CALLEGUAS MUNICIPAL WATER DISTRICT
Thousand Oaks, California

PROJECT NO. 450

FOR THE CONSTRUCTION OF THE
LVMWD-CMWD INTERCONNECTION

ADDENDUM NO. 2

DRAWING NO. C-38
 JOB NO.
 SHEET 44 OF 127

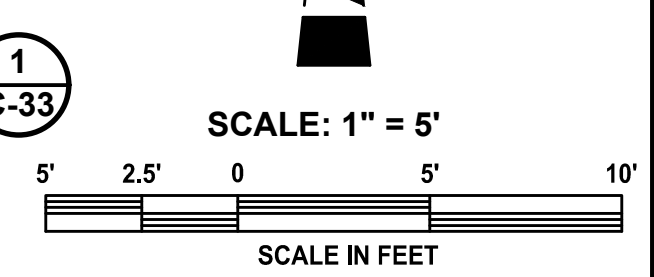
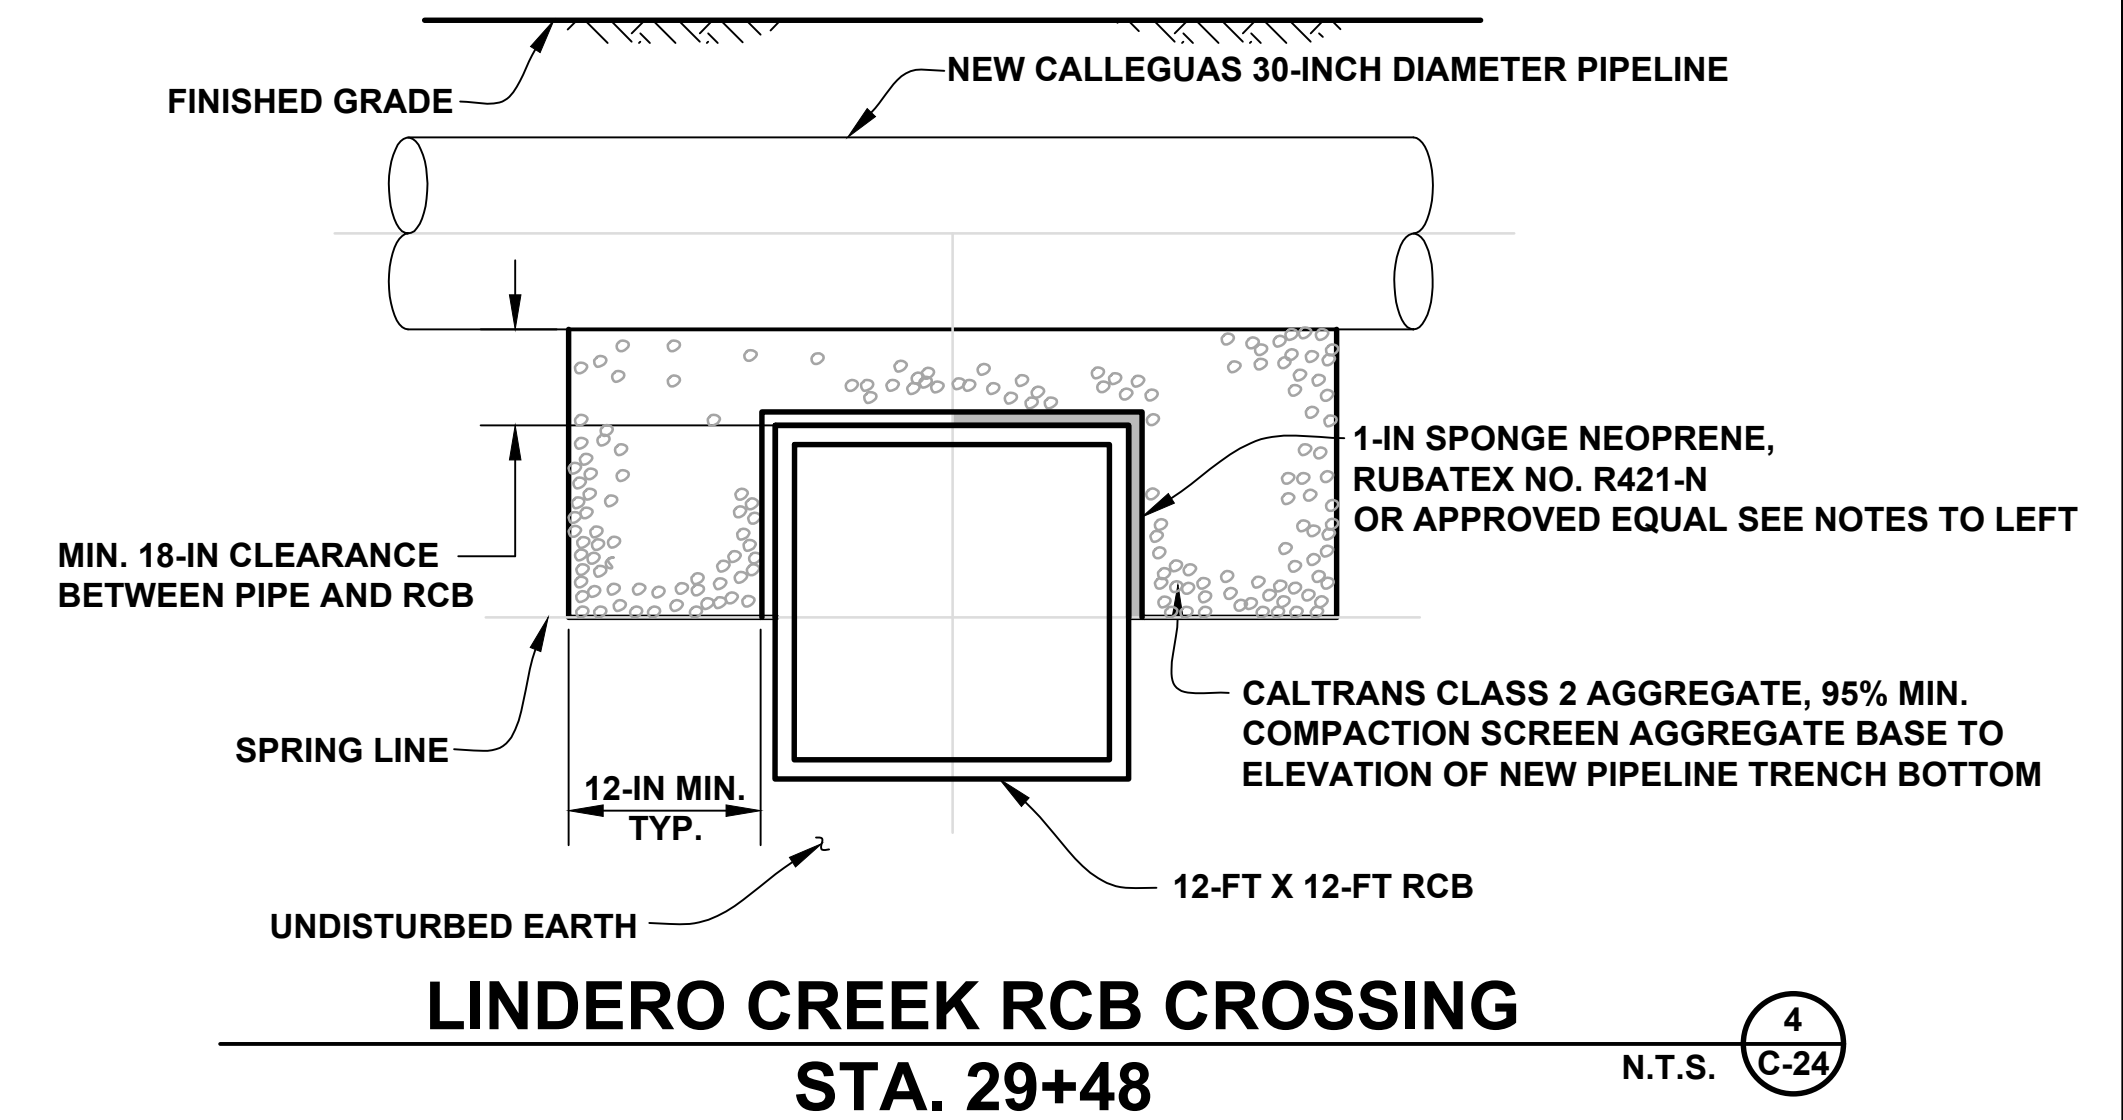
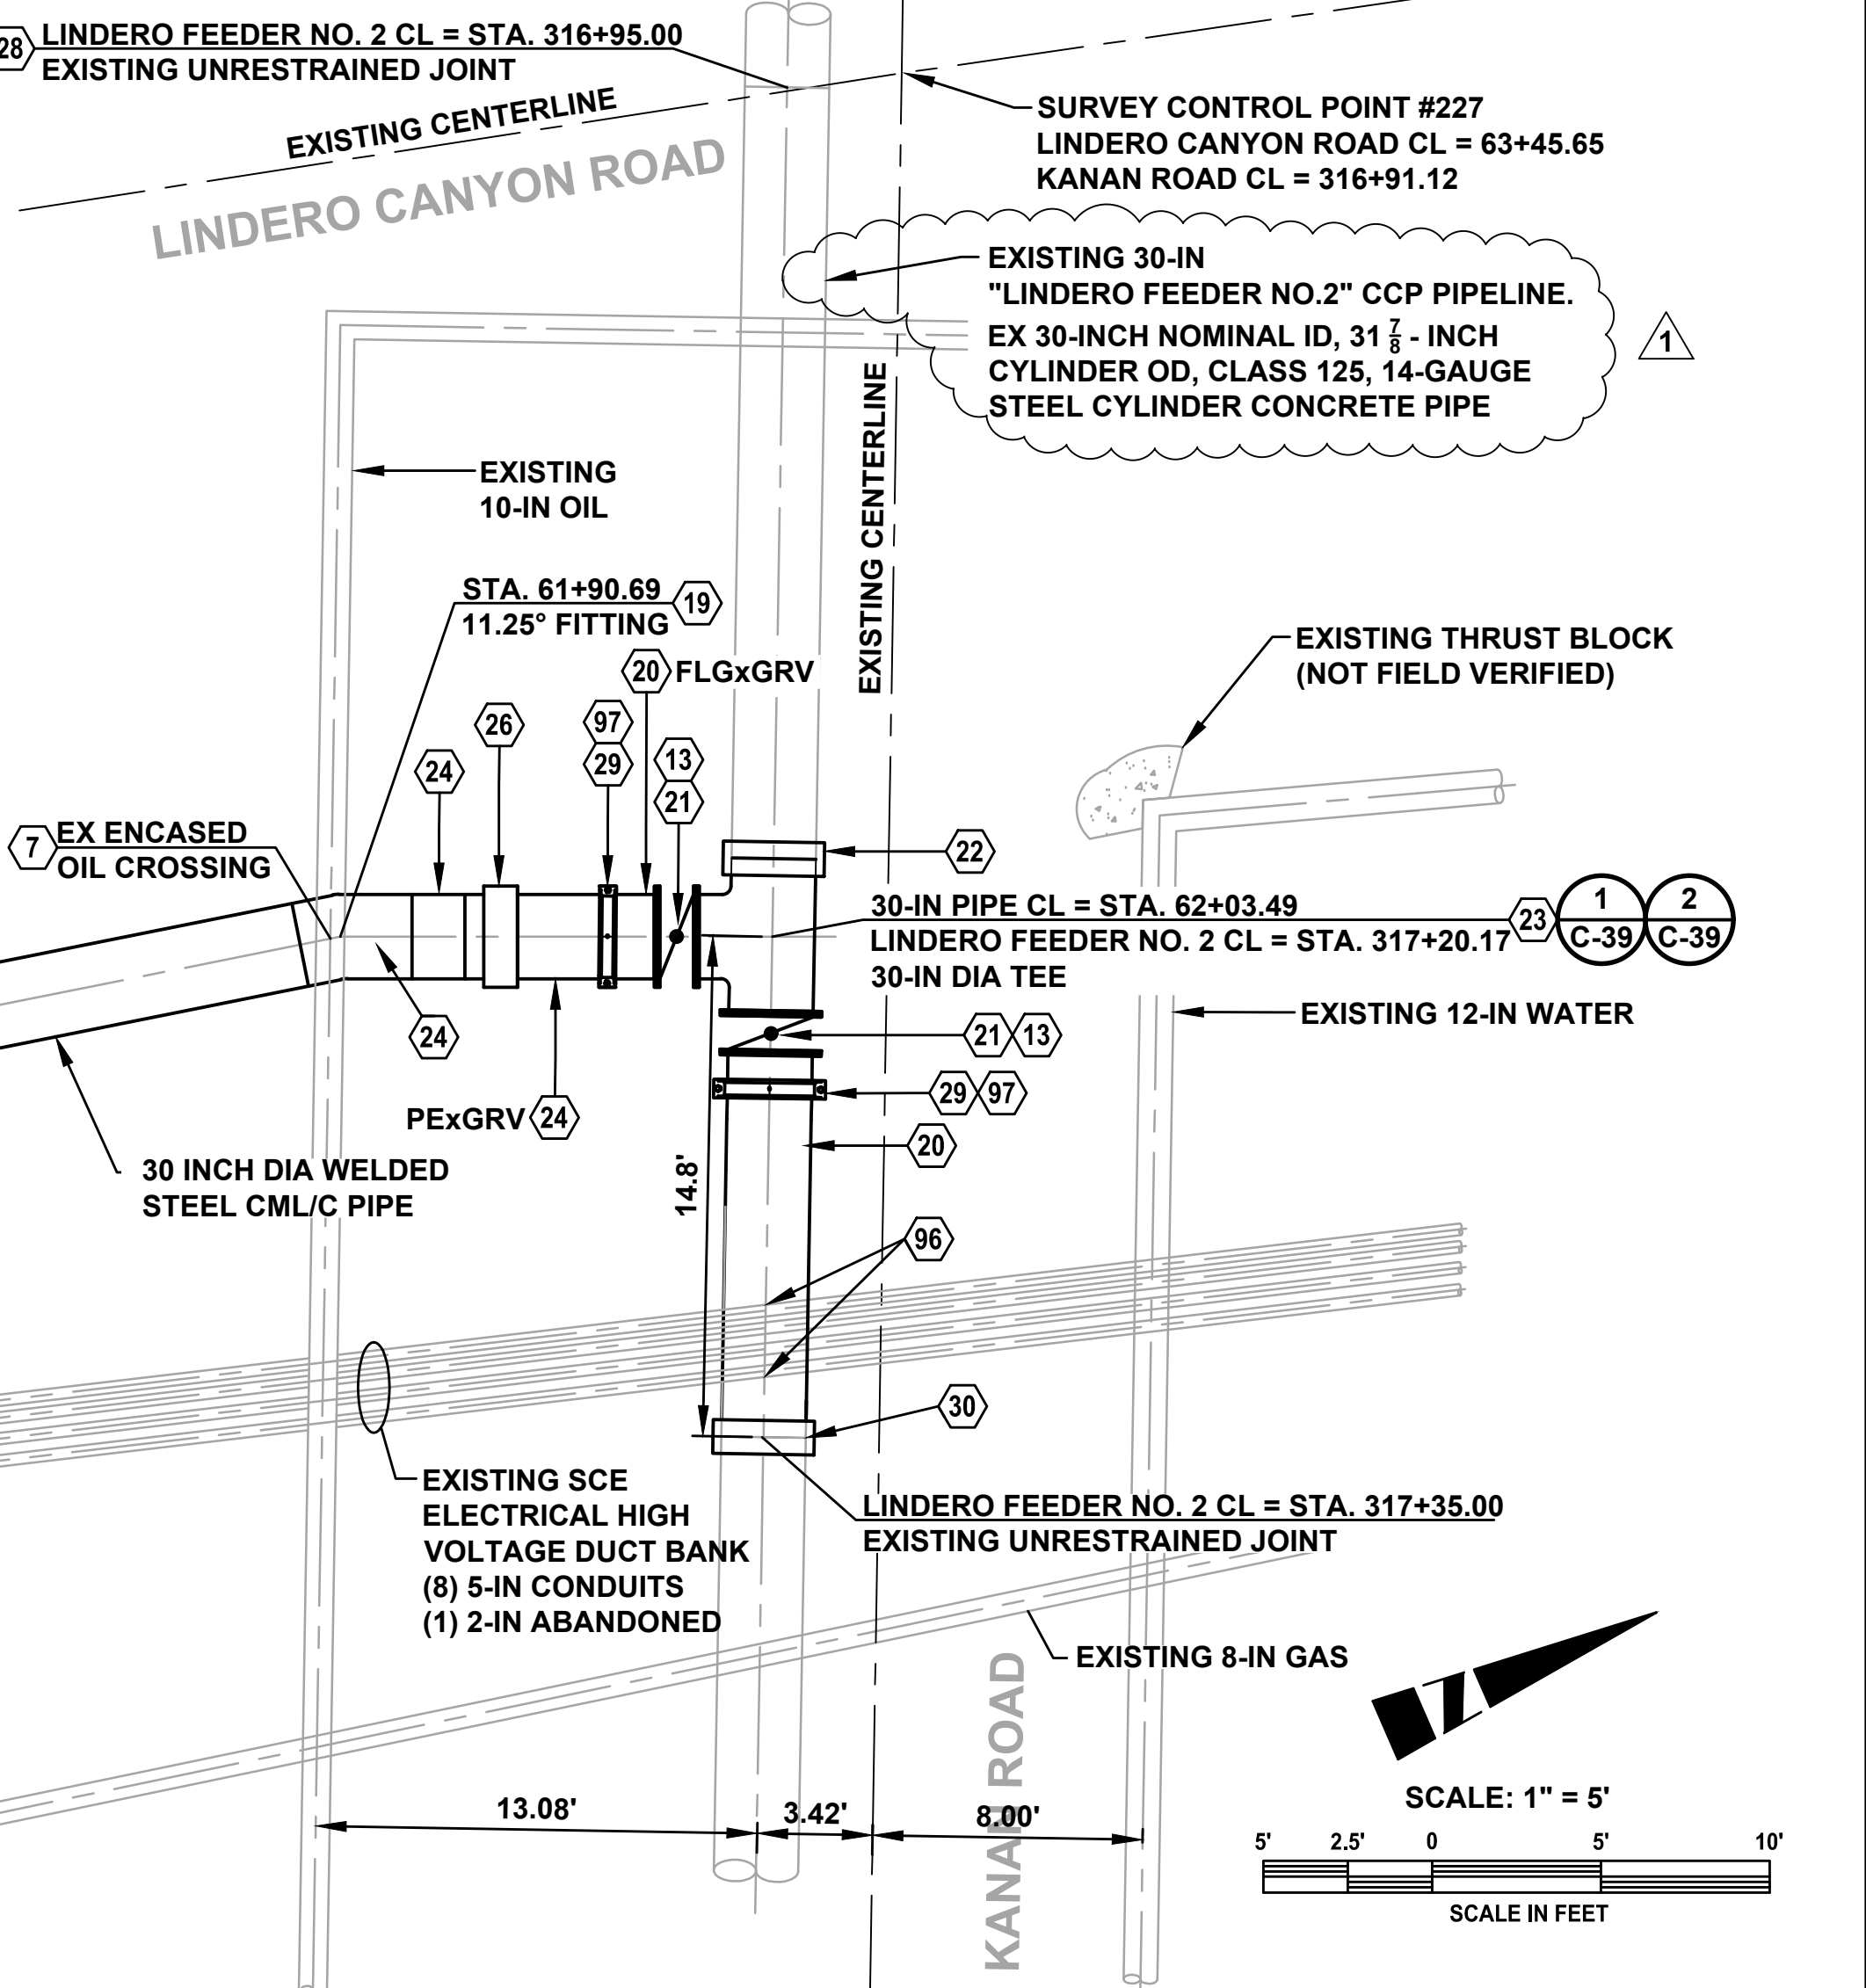
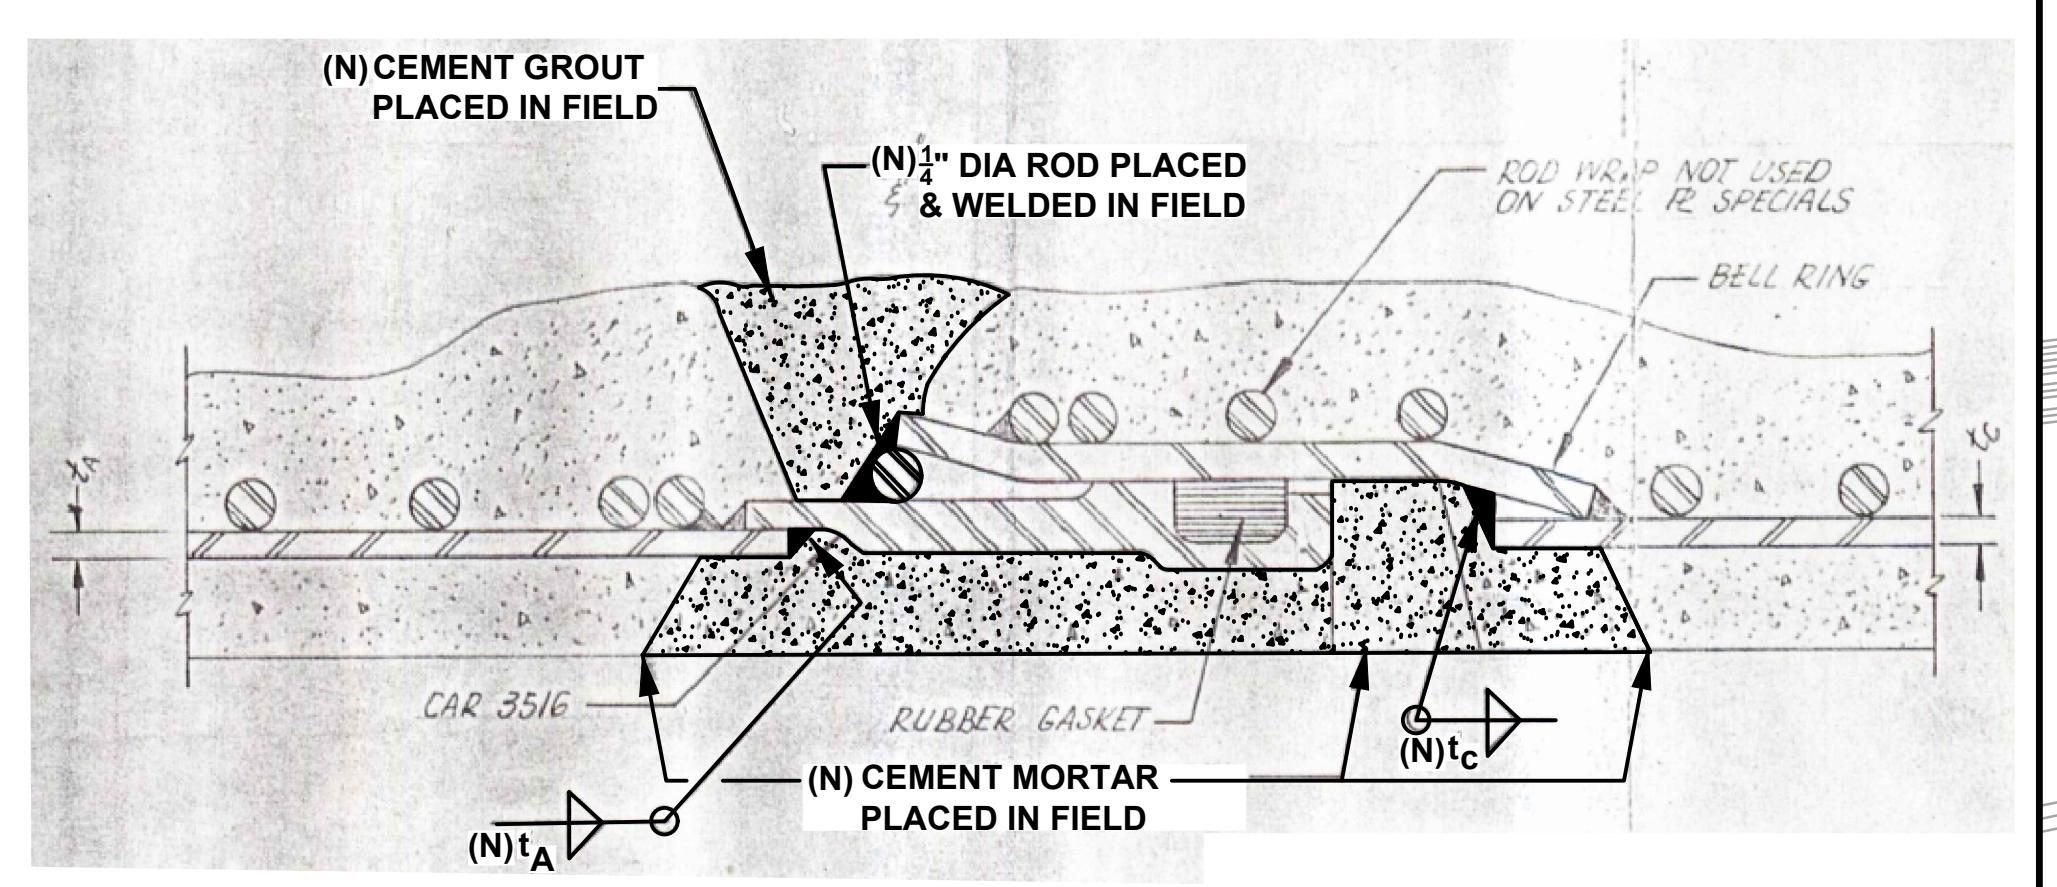
- Item AD2-54 REPLACE Drawing C-32 with the attached Exhibit H4, containing replacement Drawing C-32.
- Item AD2-55 REPLACE Drawing C-38 with the attached Exhibit H5, containing replacement Drawing C-38.
